REMARKS

AMENDMENTS TO THE DRAWINGS

Title: WAVELENGTH DIVISION MULTIPLEXED DEVICE

Serial Number: 09/940554

FIG. 1

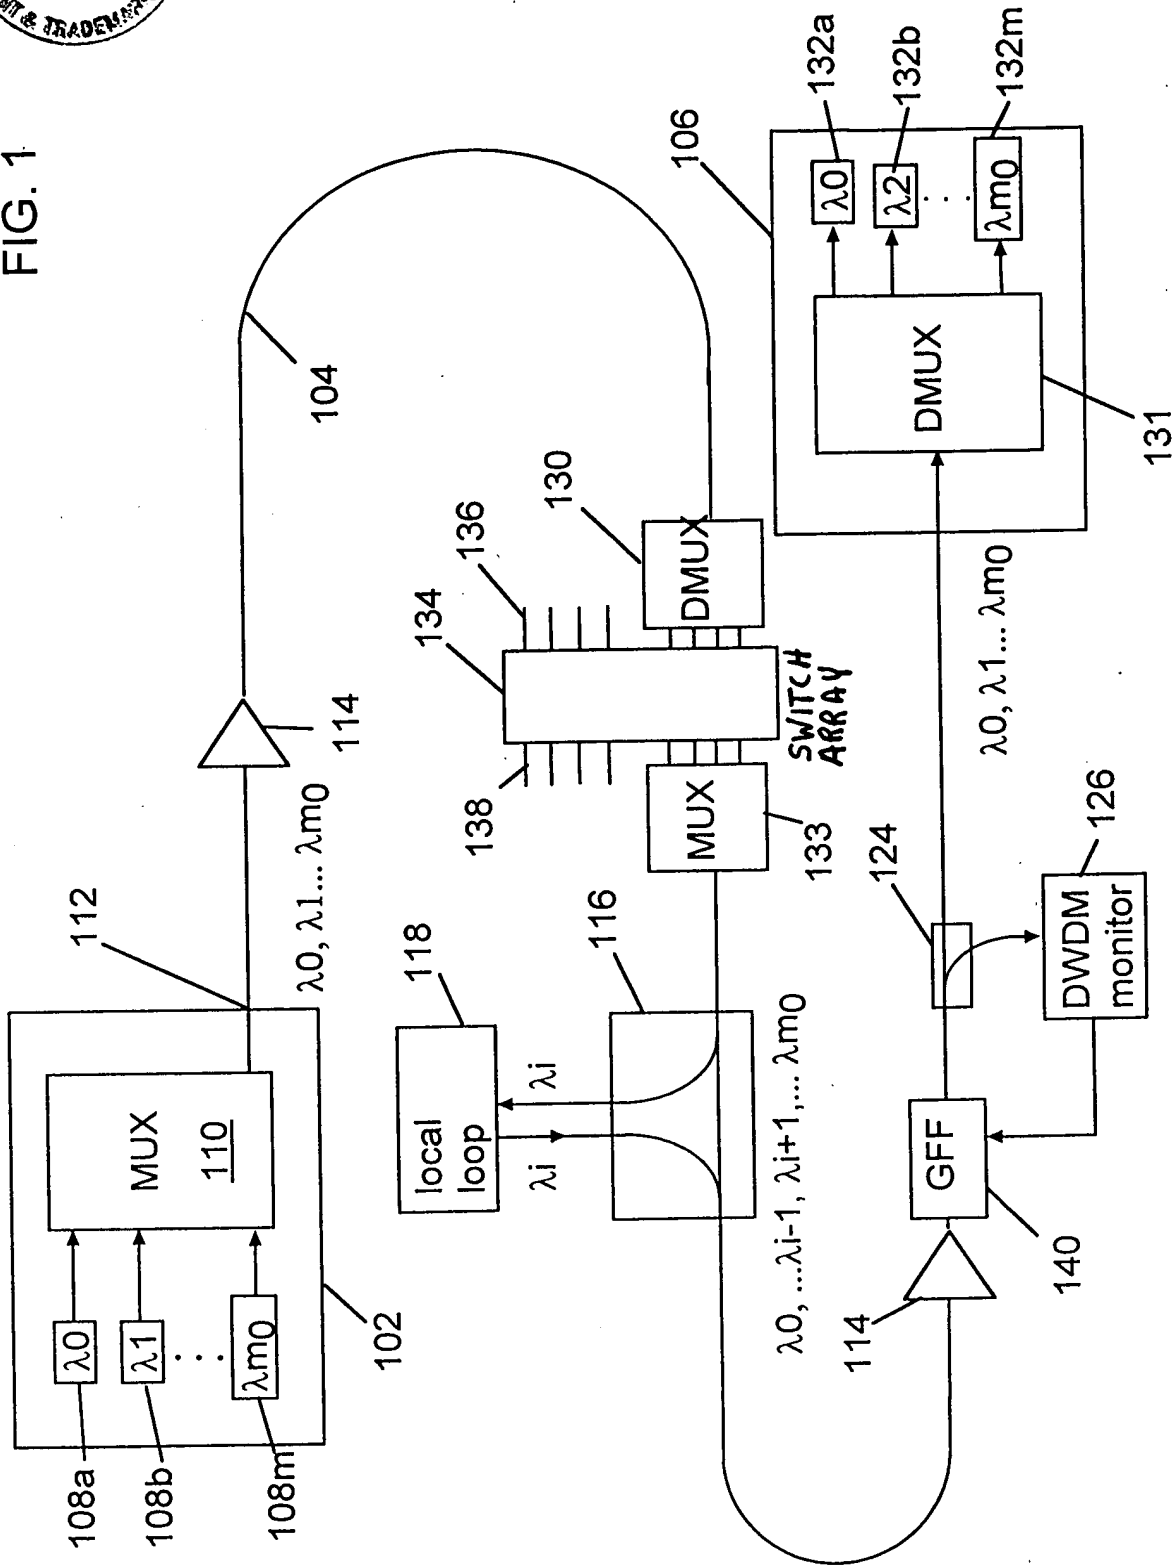
- This sheet, which contains FIG. 1, replaces the original sheet that contains FIG. 1. In FIG. 1, box 134 has been labeled SWITCH ARRAY.
- This sheet, which contains FIG. 2, replaces the original sheet that contains FIG. 2. In FIG. 2, boxes 228, 230 and 234 have been labeled WAVEGUIDE ARRAY, LIGHT HANDLING UNIT, and LENS ARRAY respectively.

FIG. 6

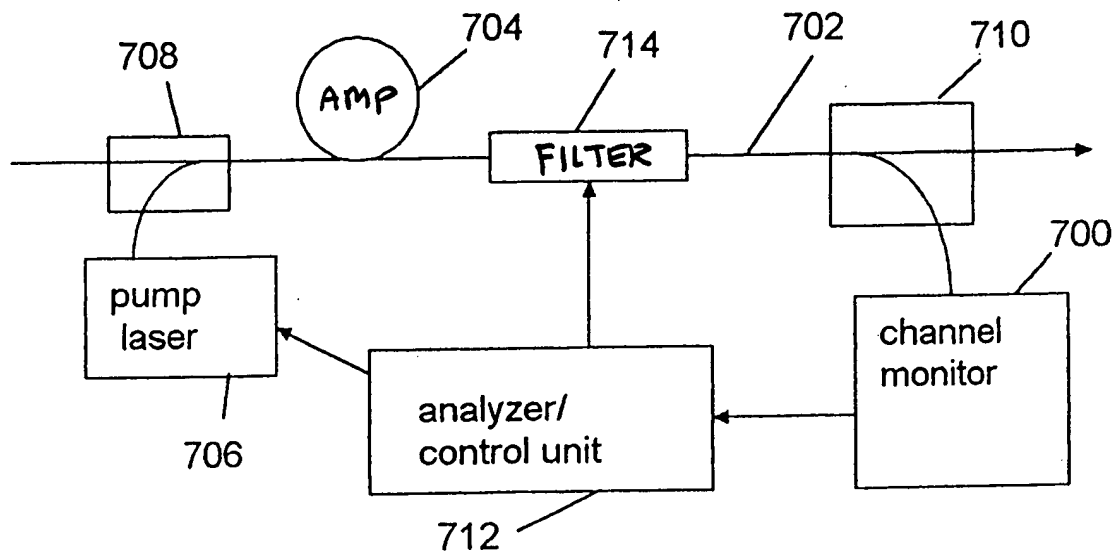
- This sheet, which contains FIG. 6, replaces the original sheet that contains FIG. 6. In FIG. 6, boxes 230, 604, 606 and 608 have been labeled LIGHT HANDLING UNIT, DETECTOR UNIT, PHOTO DETECTORS, and CHANNEL ANALYSIS UNIT respectively.

FIG. 7

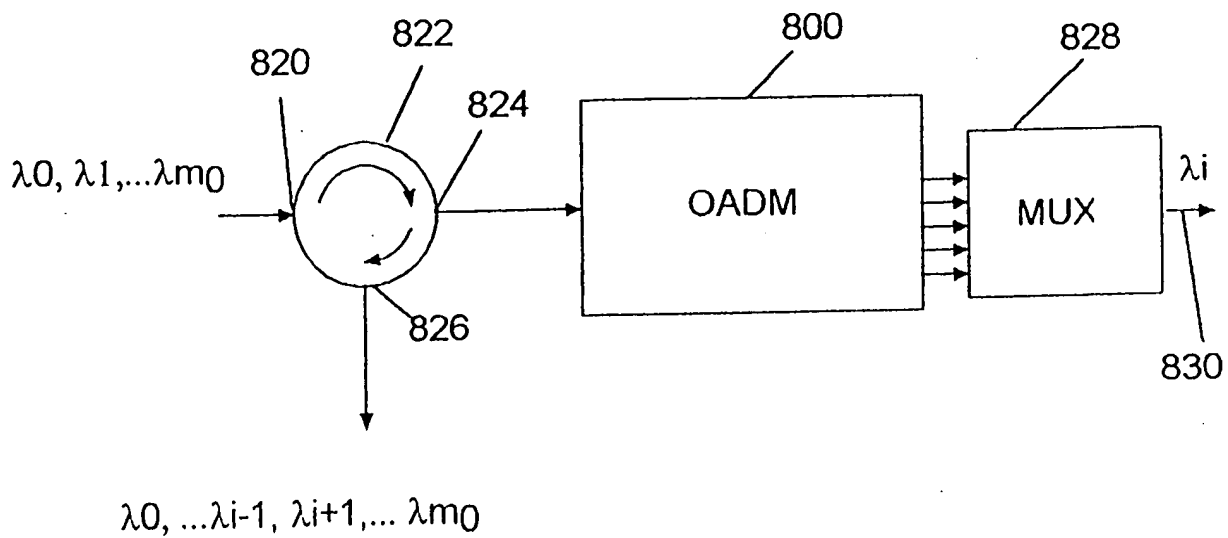
- This sheet, which contains FIGS. 7 and 10, replaces the original sheet that contains FIGS. 7 and 10. In FIG. 7, boxes 704 and 714 have been labeled AMP and FILTER respectively.

FIG. 8

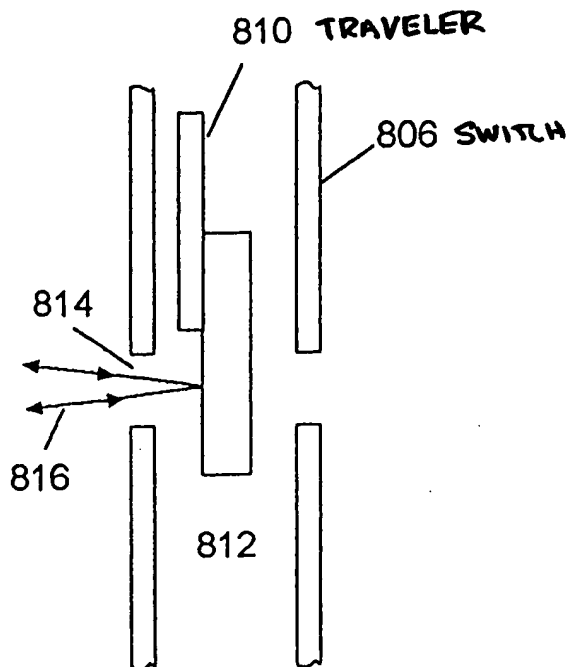
- This sheet, which contains FIG. 8, replaces the original sheet that contains FIG. 8. In FIG. 8, boxes 230, 804 and 806 have been labeled LIGHT HANDLING UNIT, SWITCH UNIT, and OPTICAL SWITCHES respectively.

FIG. 9A

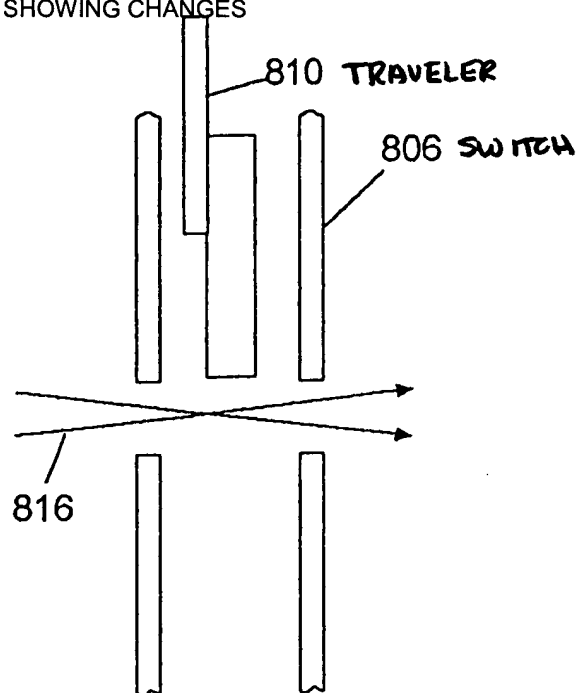
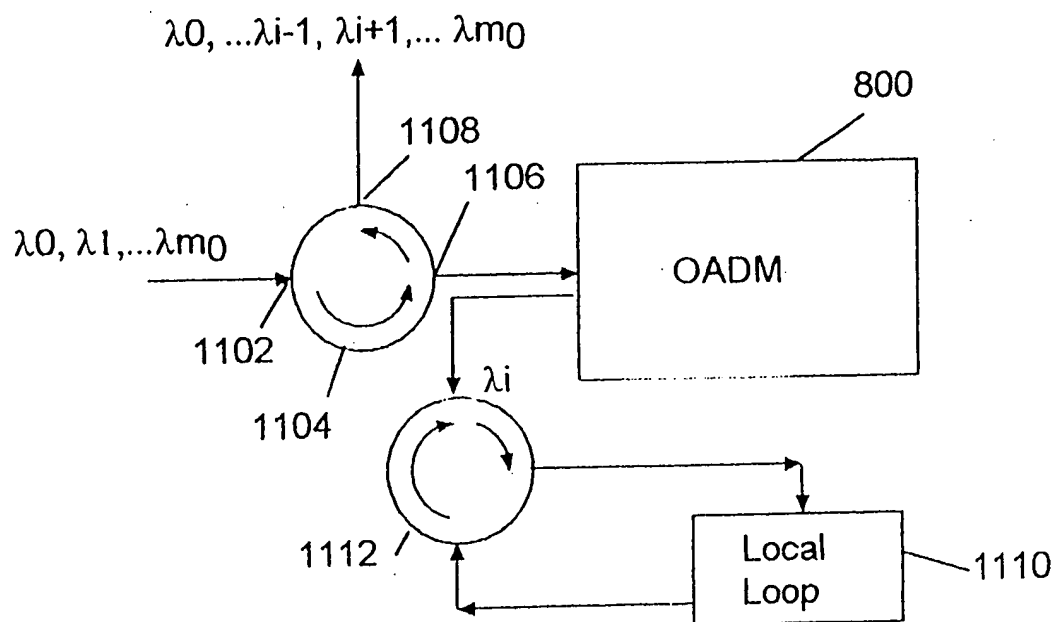
- This sheet, which contains FIGS. 9A, 9B and 11, replaces the original sheet that contains FIGS. 9A, 9B and 11. In FIGS. 9A and 9B, boxes 806 and 810 have been labeled SWITCH and TRAVELER respectively.

FIG. 17A

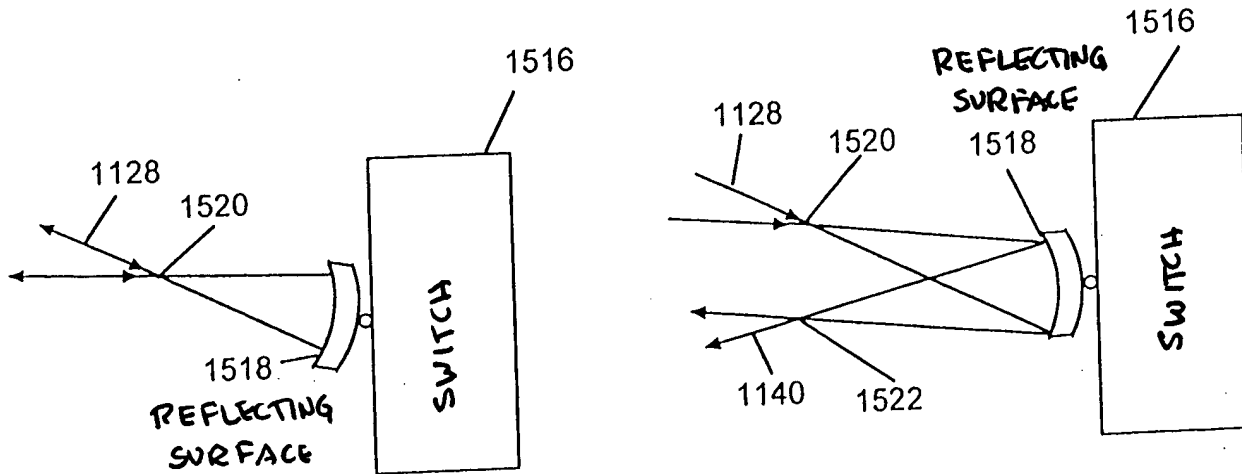
- This sheet, which contains FIGS. 16, 17A and 17B, replaces the original sheet that contains FIGS. 16, 17A and 17B. In FIGS. 17A and 17B, boxes 1516 and 1518 have been labeled SWITCH and REFLECTING SURFACE respectively.

FIG. 18A

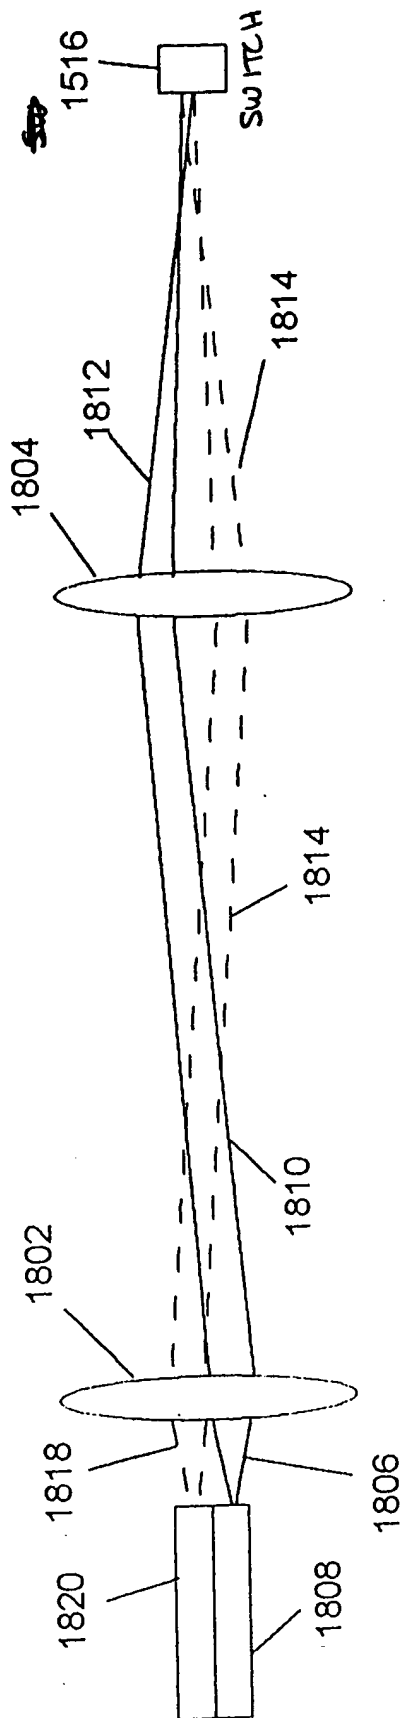
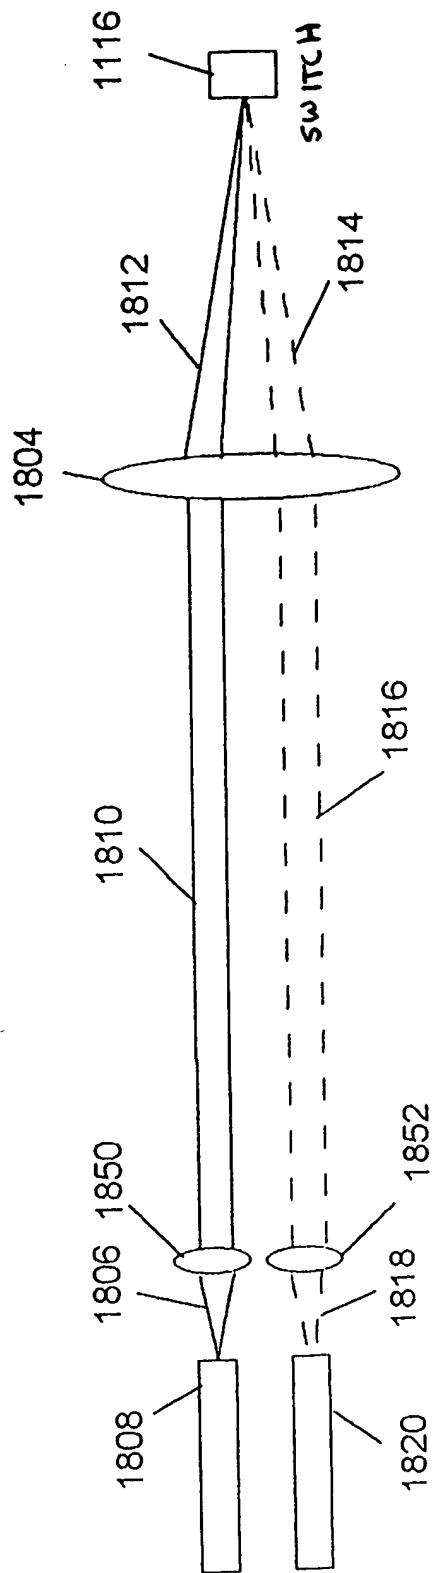
- This sheet, which contains FIGS. 18A and 18B, replaces the original sheet that contains FIGS. 18A and 18B. In FIGS. 18A and 18B, boxes 1116 and 1516 have both been labeled SWITCH.

FIG. 20

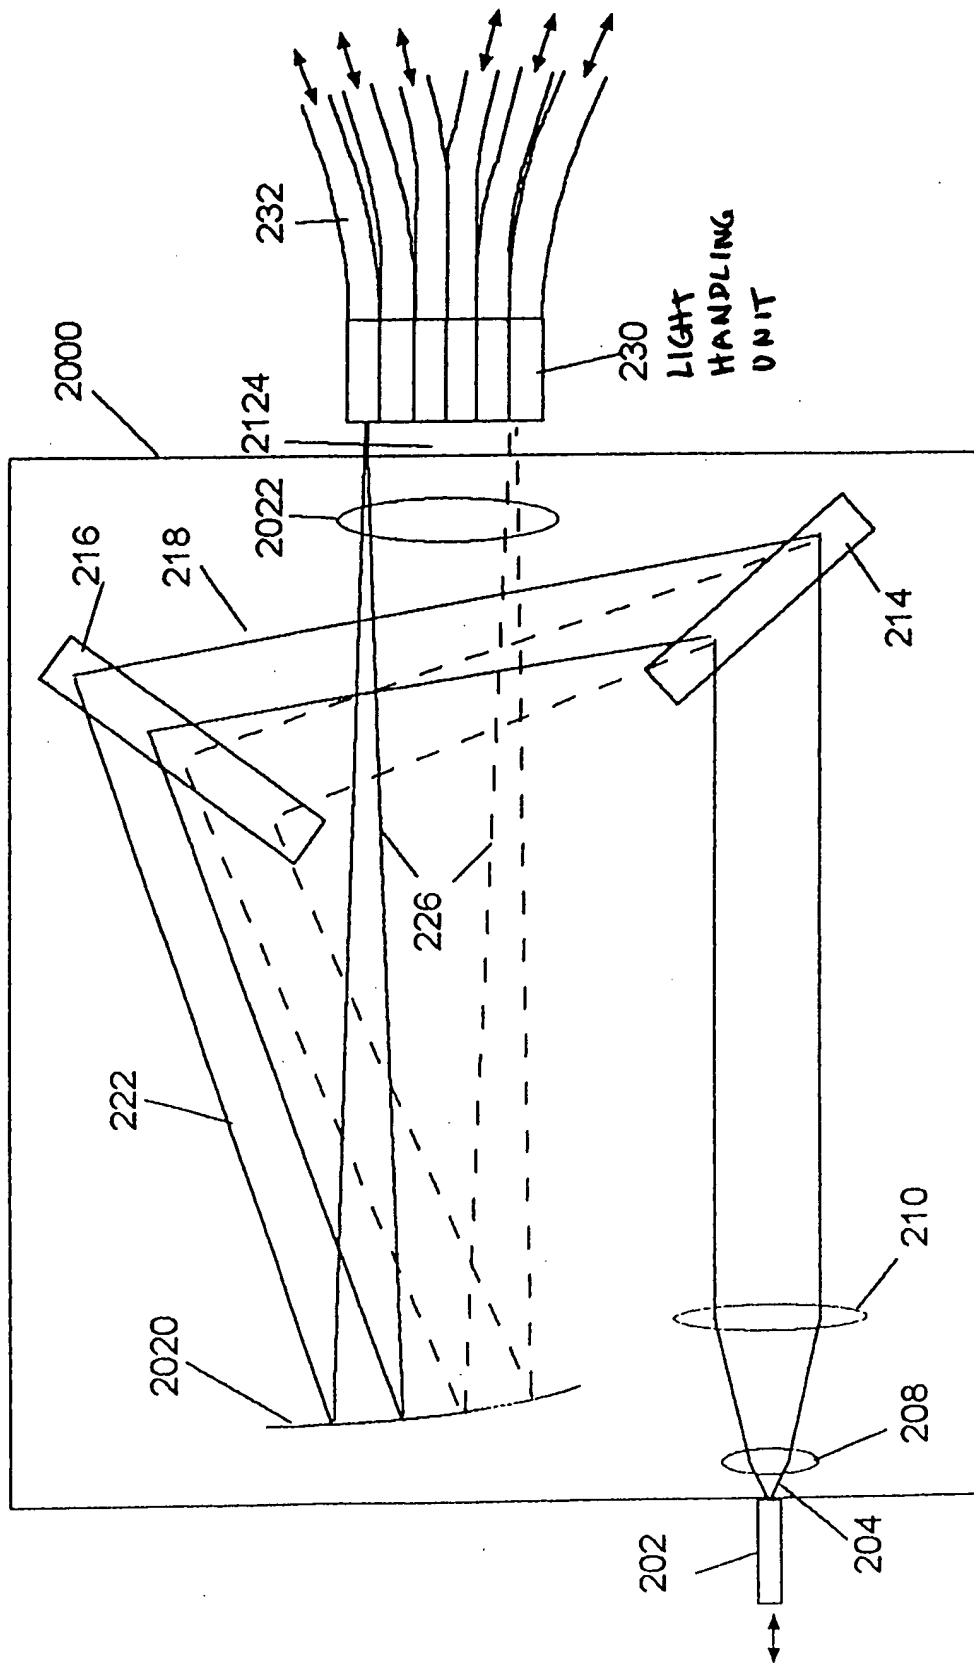
- This sheet, which contains FIG. 20, replaces the original sheet that contains FIG. 20. In FIG. 20, box 230 has been labeled LIGHT HANDLING UNIT.
- This sheet, which contains FIG. 21, replaces the original sheet that contains FIG. 21. In FIG. 21, box 2130 has been labeled LIGHT HANDLING UNIT.

FIG. 22

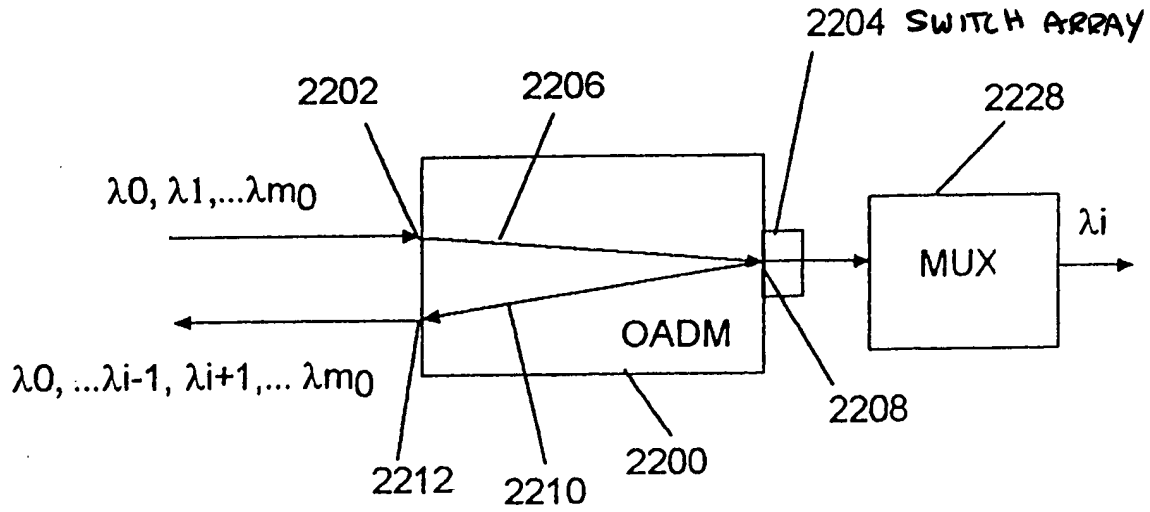
- This sheet, which contains FIGS. 22 and 29, replaces the original sheet that contains FIGS. 22 and 29. In FIG. 22, box 2204 has been labeled SWITCH ARRAY.

FIG. 28

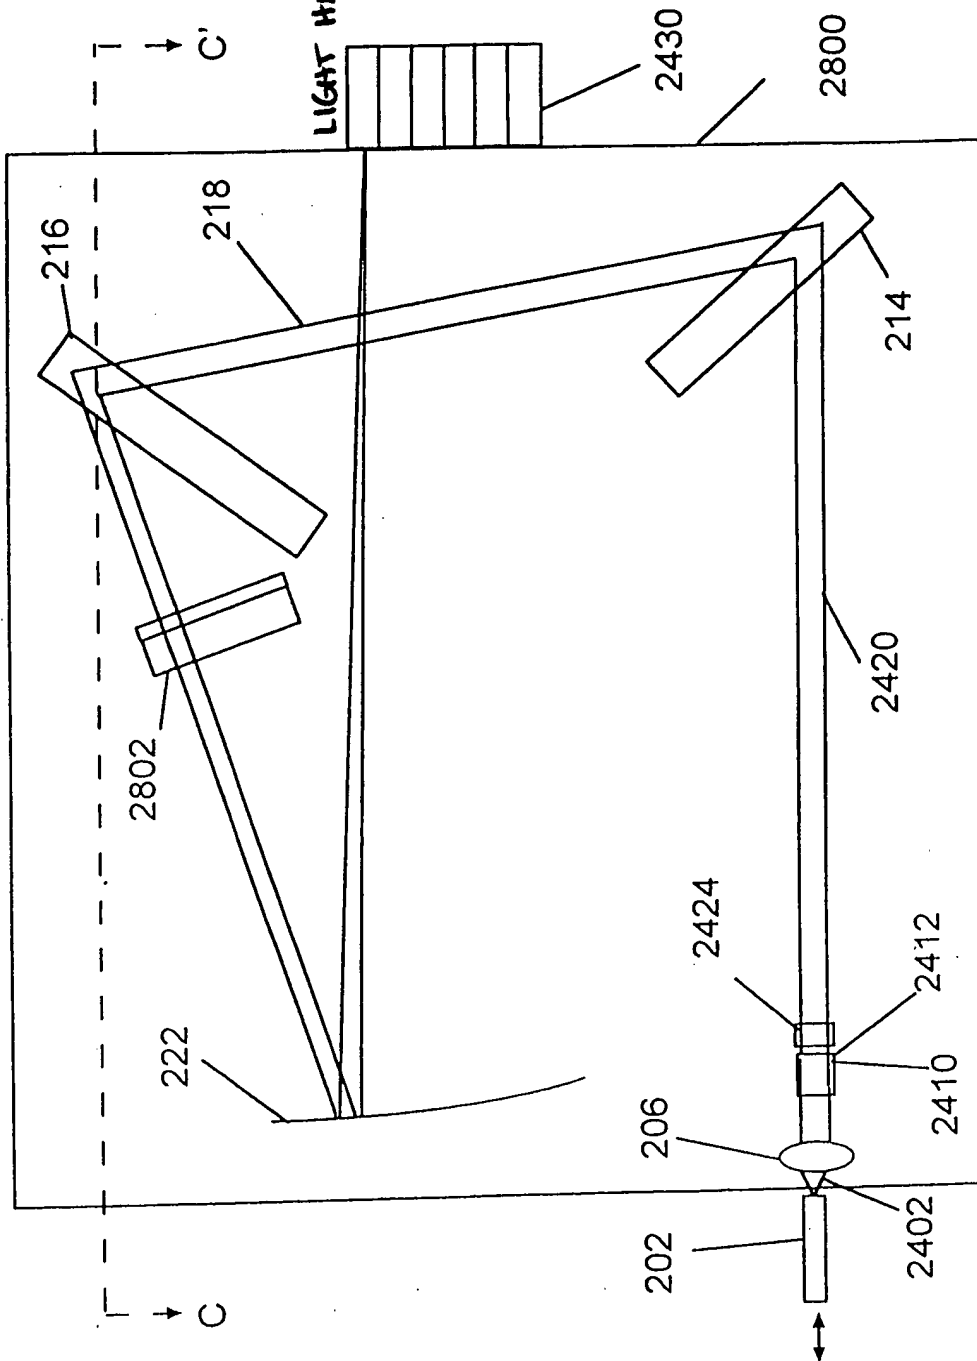
- This sheet, which contains FIG. 28, replaces the original sheet that contains FIG. 28. In FIG. 28, box 2430 has been labeled LIGHT HANDLING UNIT.
- This sheet, which contains FIGS. 31, 32 and 33, replaces the original sheet that contains FIGS. 31, 32 and 33. In FIG. 31, box 3104 has been labeled SWITCH ARRAY. In FIG. 32, boxes 3108 and 3203 have been labeled SWITCH and REFLECTOR respectively. In FIG. 33, box 3104 has been labeled SWITCH ARRAY.
